Technical note: Accounting for snow in the estimation of root-zone water storage capacity from precipitation and evapotranspiration fluxes

R1 comments:

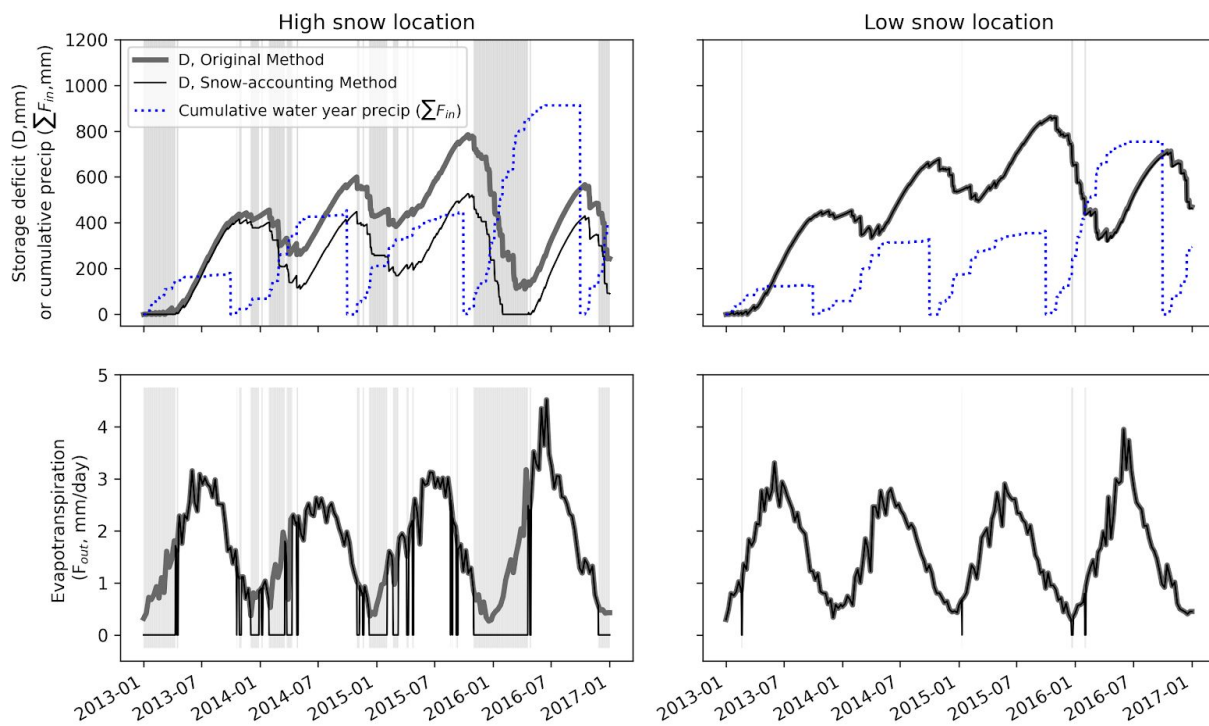
Fig.2. Maybe also add precipitation here, to have D, Fin and Fout all together.

Good suggestion, we propose to add this flux (light blue, dashed lines) to the top plot in figure 2:
